# PERFORMANCE BULLETIN

**Pentair**  
Water Treatment

## Improved 2" Plastic Remote Meter Bracket

New StyleOld Style

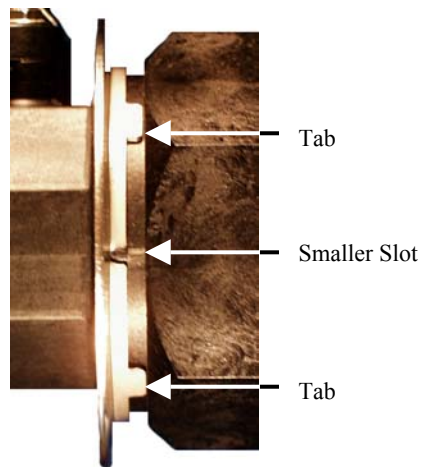
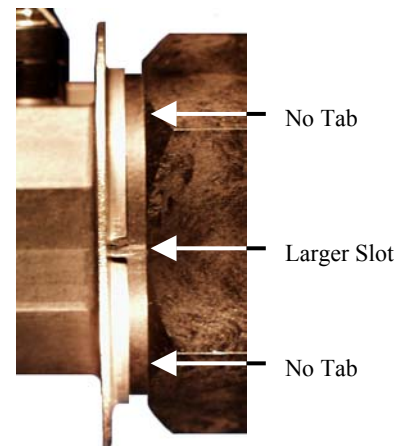
We have undergone an improvement to the remote meter timer bracket. This improvement will decrease the movement the bracket had holding the remote meter power head timer. We added four tabs to stop the side-to-side movement and decreased the slot size for the up and down movement. This bracket will be in production September 20, 2000.
